Re: Roberts Road Quarry MOD 2 (DA 267-11-99)

**Roberts Road Quarry Modification 2 (DA 267-11-99 Mod 2)
Response to exhibition of Environmental Impact Statement**

Roberts Road Quarry Modification 2 (DA 267-11-99 Mod 2) Response to exhibition of EIS Detailed comments - DPI Water

Figure 2 AGT report hydrograph

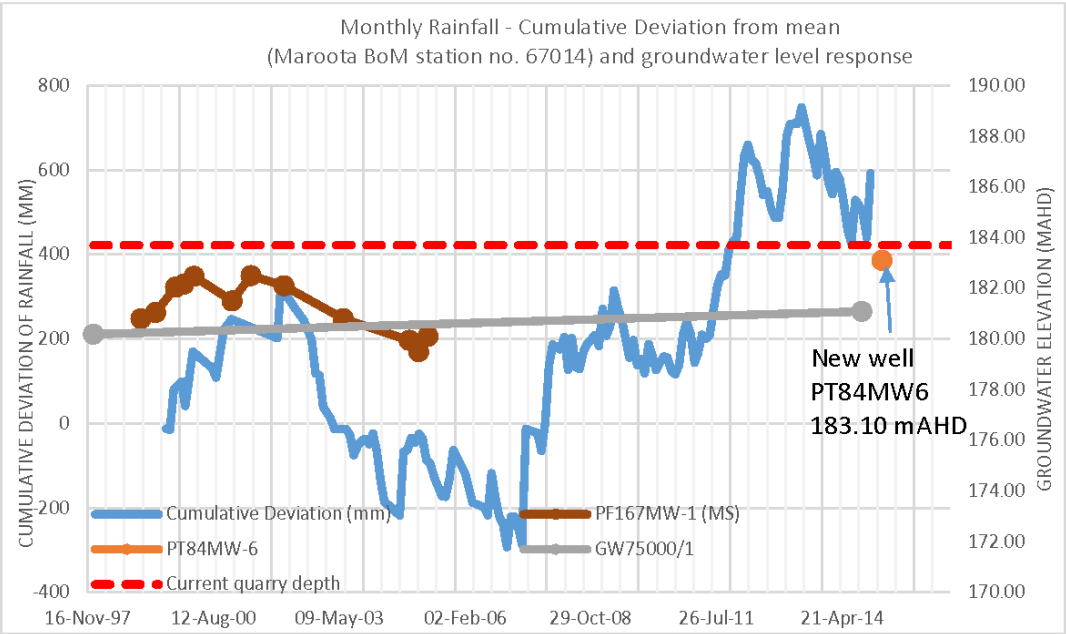
A hydrograph provided in the AGT report (p.16) illustrates the data considered in the assessment (Figure 2).

- 12 measurements of groundwater level from an off-site bore (PF167MW-1, located 750m to the southwest) all recorded prior to May 2005.
- 2 measurements of groundwater level from a NSW Government monitoring bore (GW075000/1, located 1,300m to the southwest) in around November 1997 and around April 2014.
- 1 measurement from the single on-site monitoring bore (PT84MW-6, installed as a replacement for PT84MW-3) on 3 March 2015.

That hydrograph highlights the encroachment of extraction on the water table, as the identified current quarry depth is considerably less than 2m above the groundwater level measured in March. This is illustrated by a cross section in the AGT report (p.18), which is reproduced below (Figure 3).

- Restriction on the absolute depth of extraction to 186.08m AHD for the entire period of quarry operation (regardless of any future extension to the consent) unless higher wet weather groundwater levels become apparent.

Figure 3 AGT report cross section

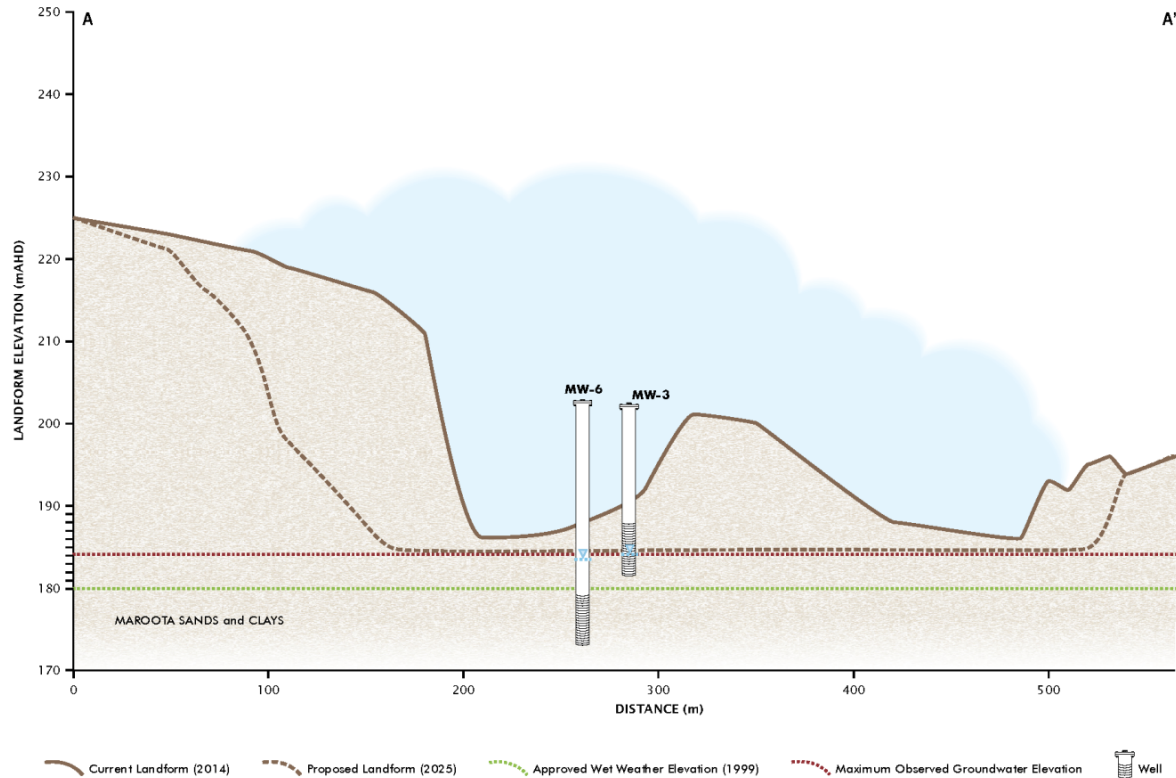
- It is of concern that current excavation cells with base elevations of less than 186.08m AHD are less than 2m from the water table. There is no documentation about filling over excavated areas with Natural Excavated Materials (NEM) or Virgin Excavated Natural Materials (VENM)—in accordance with EPA Guidelines—to achieve the elevation requirement.
